February 11, 2020
Revised March 24, 2020

RE: Reconsideration Letter and Additional Comments Regarding Site Investigation Addendum for the Block System Cleaners Facility Located at 2017 Winnebago Street in Madison, Wisconsin – BRRTS No. 02-13-552132; ReadyEarth Project no. 11-0604

B.1.b Detailed Site Map
 Block System Cleaners
 2017 Winnebago Street
 Madison, Wisconsin

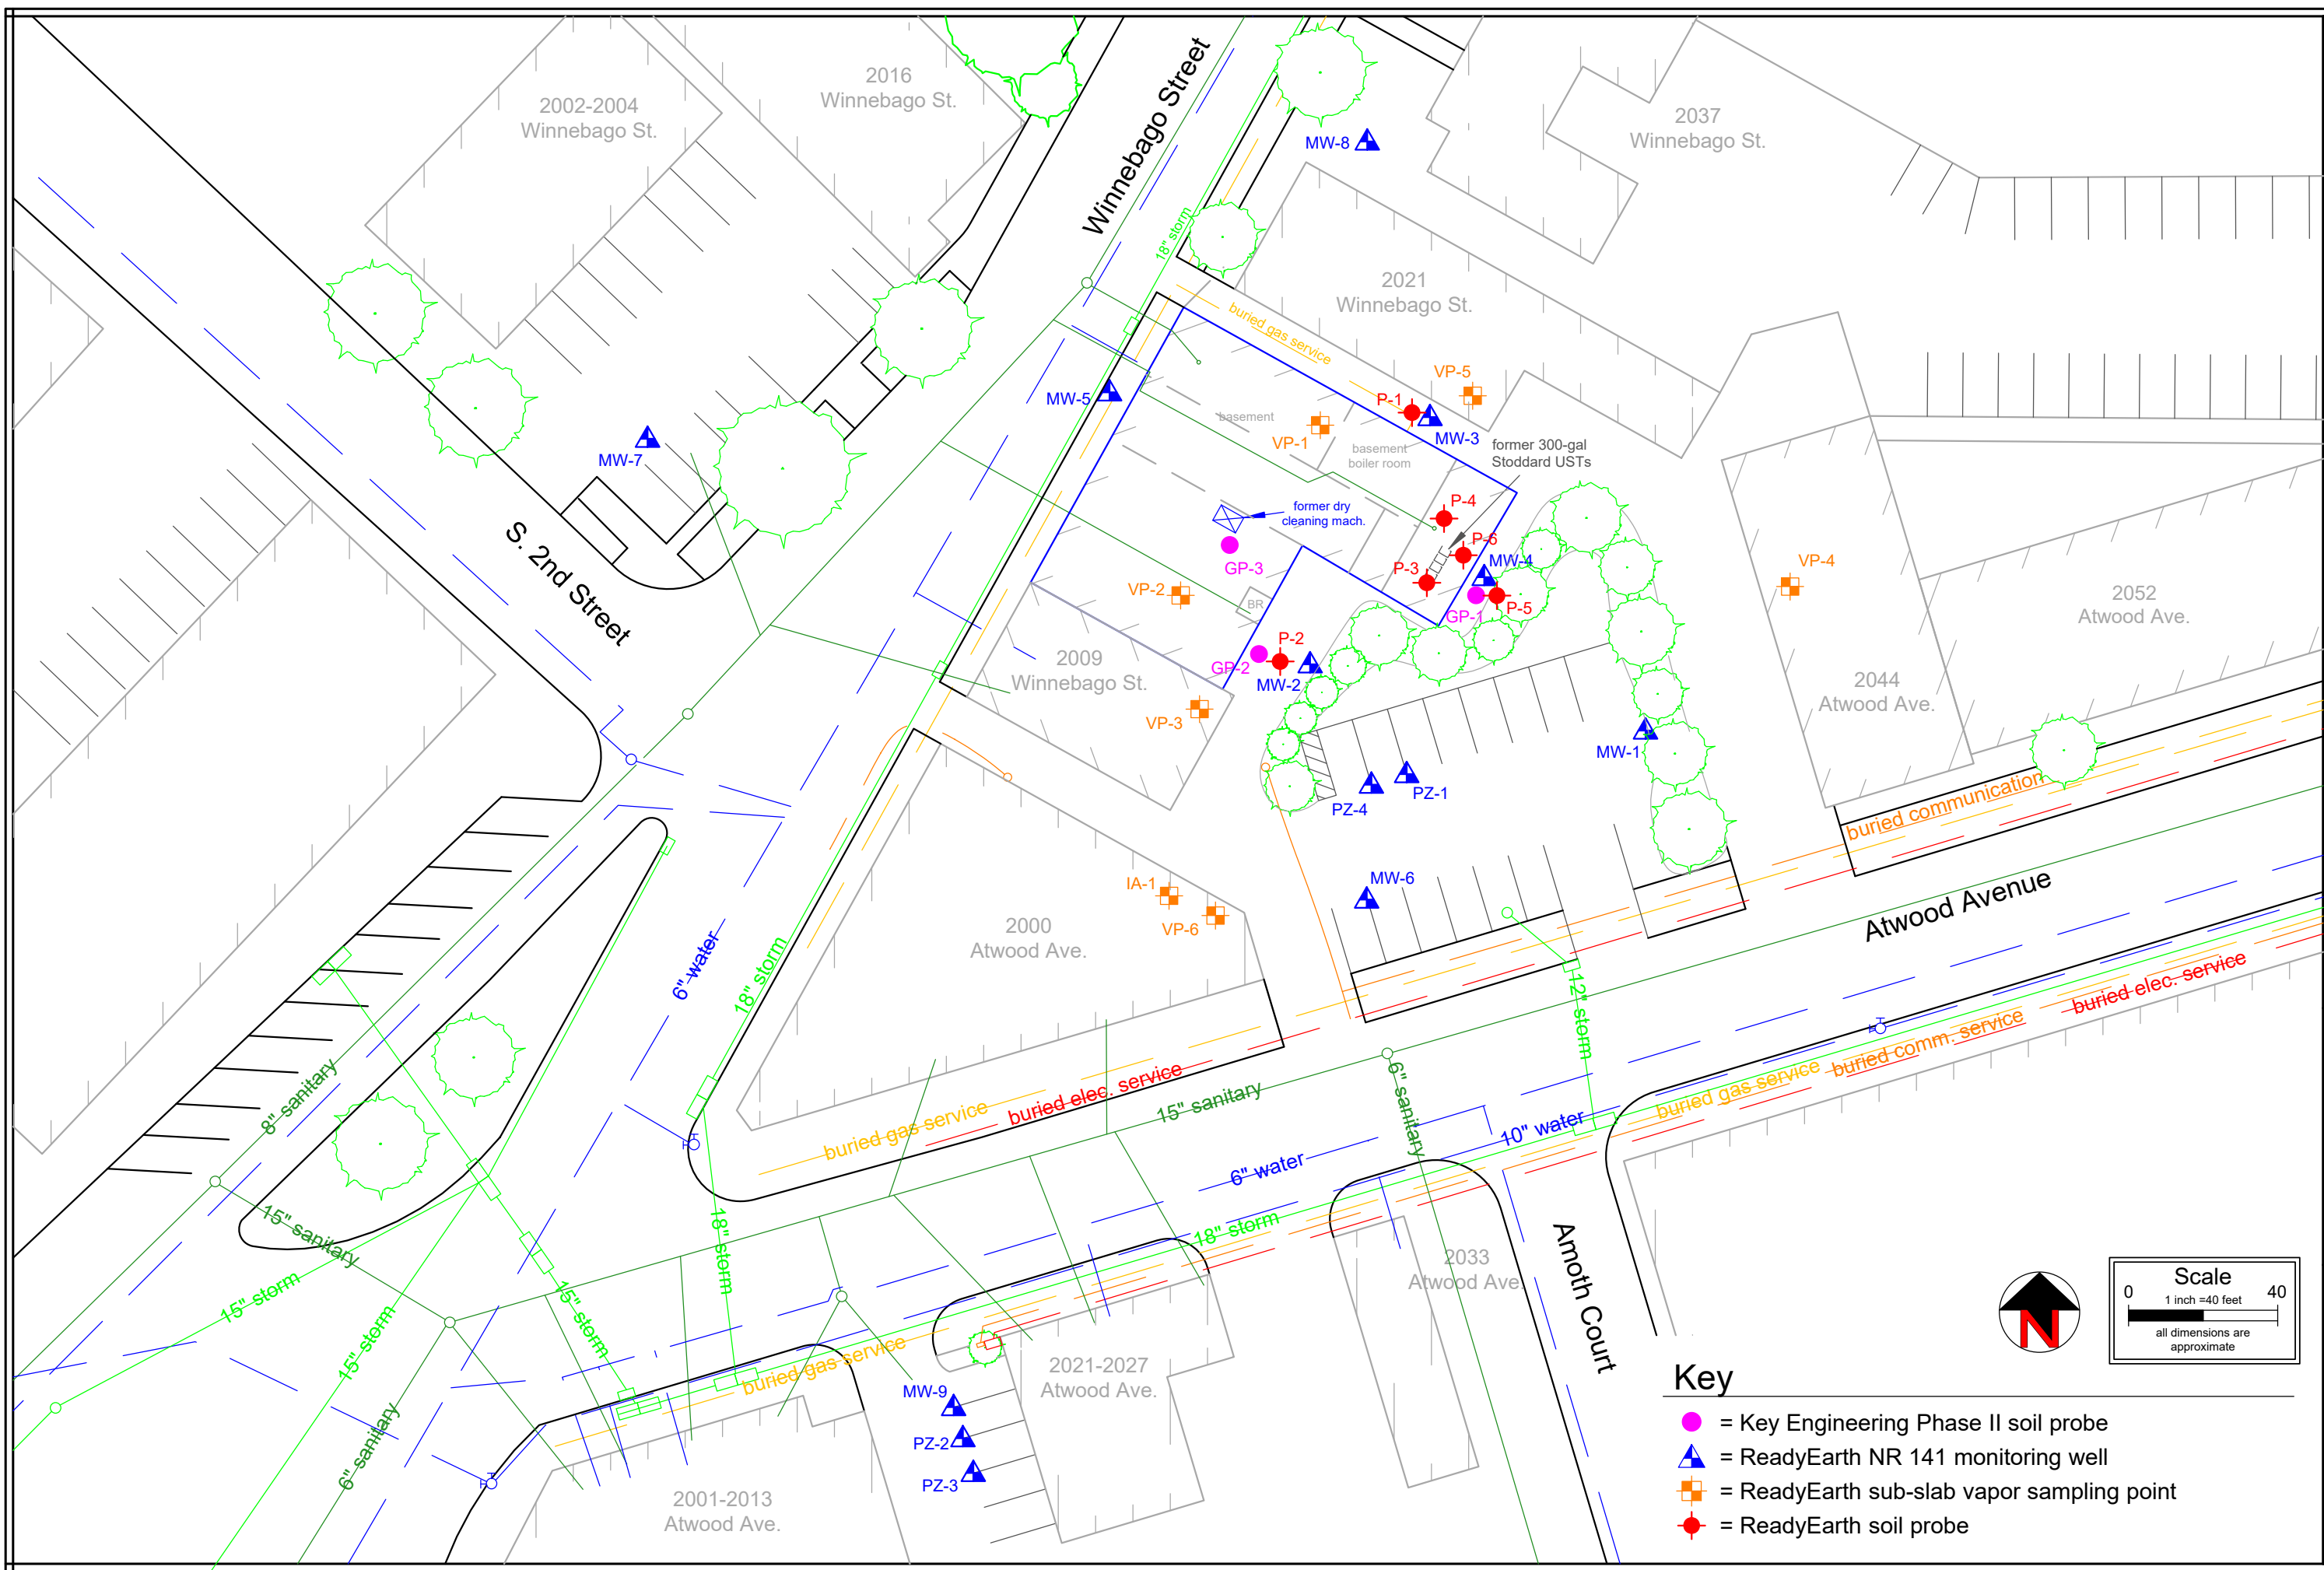
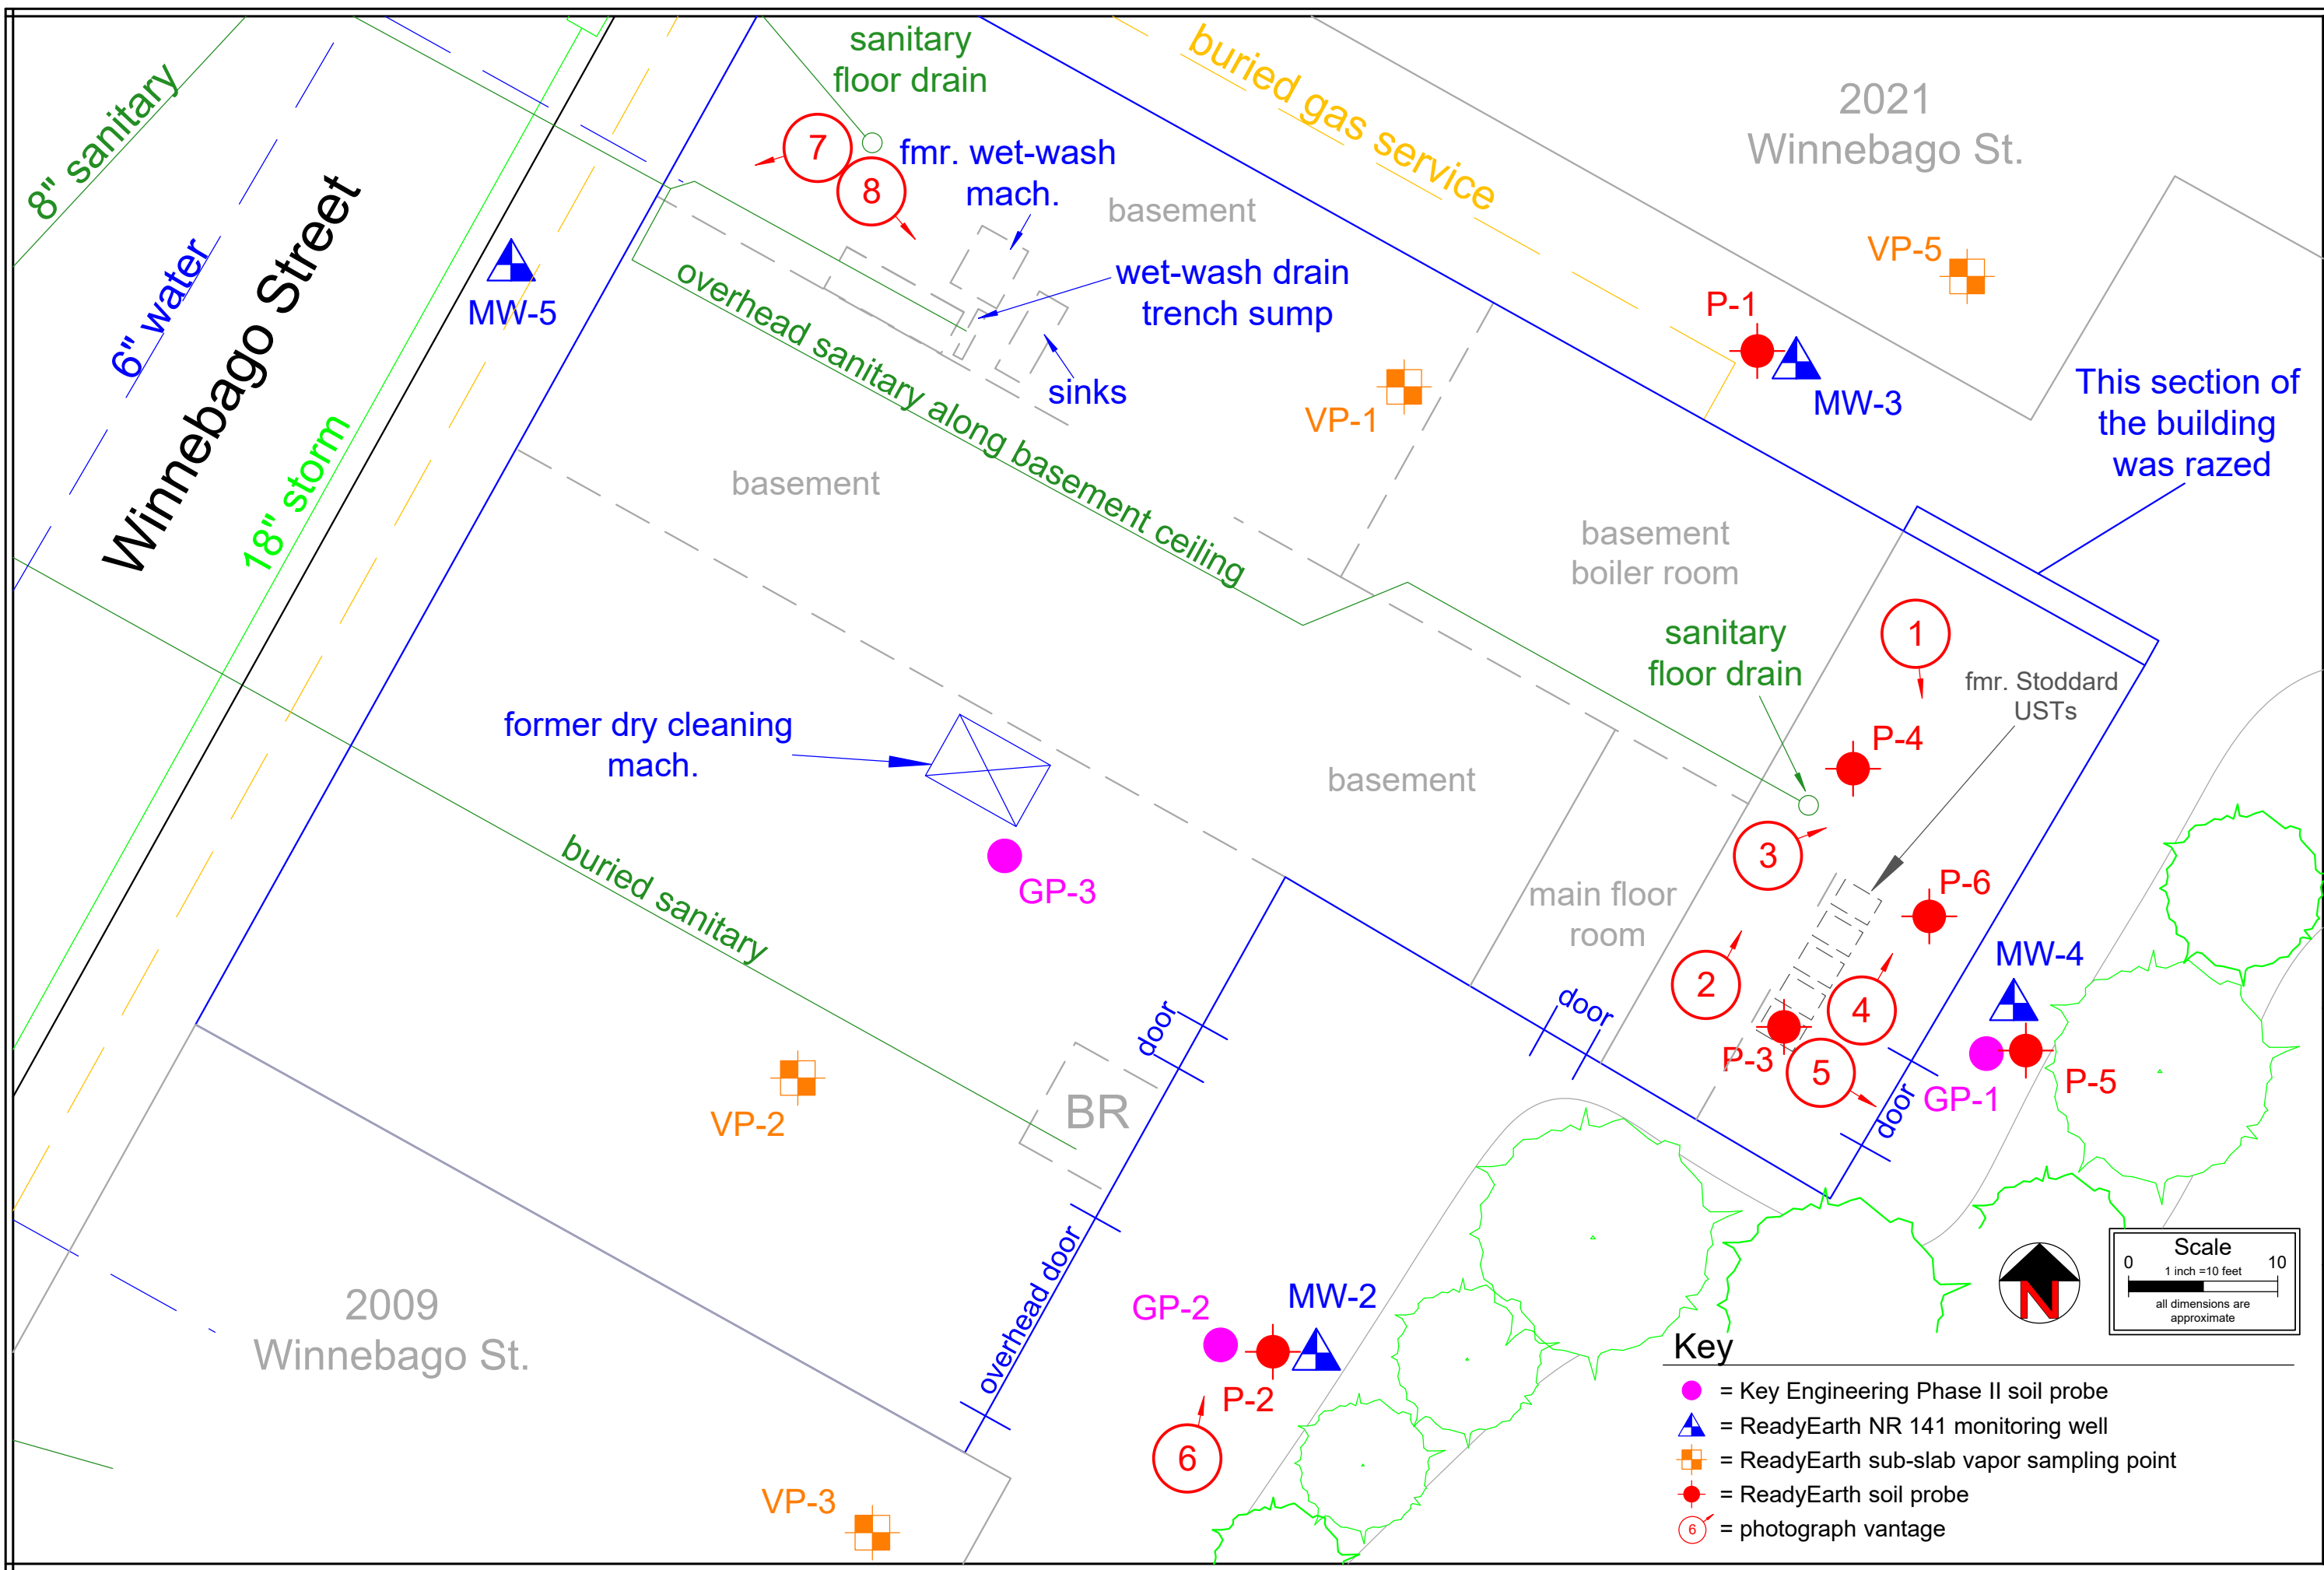
8. The DNR has requested additional information regarding buried utilities, locations of sumps in the building, locations of quick connects for the former PCE dry cleaning machine, and locations of exterior doors for the Block building:

- The buried utilities are indicated on the figure B.1.b.1 Detailed Site Map included in Attachment B. The locations of these utilities have been determined from maps obtained from the City of Madison Engineering Department and/or have been determined through a utility locate.

- Figure B.1.b.2 Detailed Site Map Zoom included in Attachment B highlights even more details in the vicinity of the most-likely former source area and basement of the Block building. That figure details the former floor drain previously referenced, the wet-wash trench sump discussed in our phone call, and exterior doors to the Block building near the former source area. Note that the wet-wash trench sump collected water from a typical powder detergent washer machine and is not a foundation sump. Water from the trench was pumped via traditional sump pump to the sanitary sewer on the Winnebago Street side of the building.

Photo 1 – This photograph looks south across the rear storage room. A rear exterior door shown in the left background leads from this room to the area where MW-4 is located. The building areas shown in this photo have been razed.

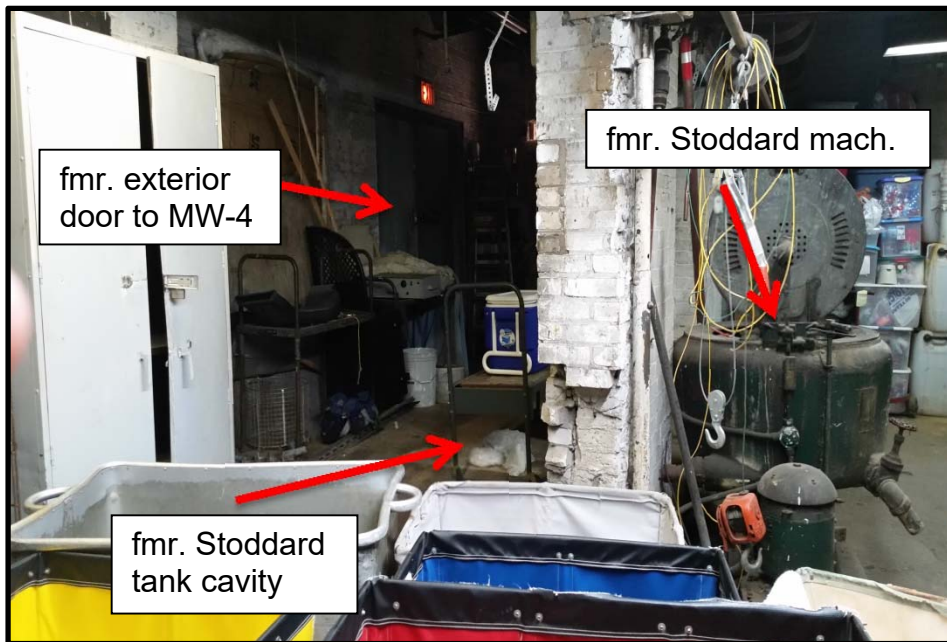
- A rear door to the building (now razed) had been located adjacent to MW-4 (shown on the maps and photographs included in Attachment B).
 - A former floor drain had been located in the rear portion of the building (now razed). The floor drain elbowed underground and then into the basement where it then ran along the ceiling to discharge to the sanitary sewer on the Winnebago Street side of the building (near MW-5). Probehole P-4 was advanced in the immediate vicinity of the former floor drain with no impacts detected. The location of the floor drain and P-4 are illustrated on the figures and photographs in Attachment B. Figure B.1.b.2 Detailed Site Map Zoom in Attachment B depicts the photograph locations.
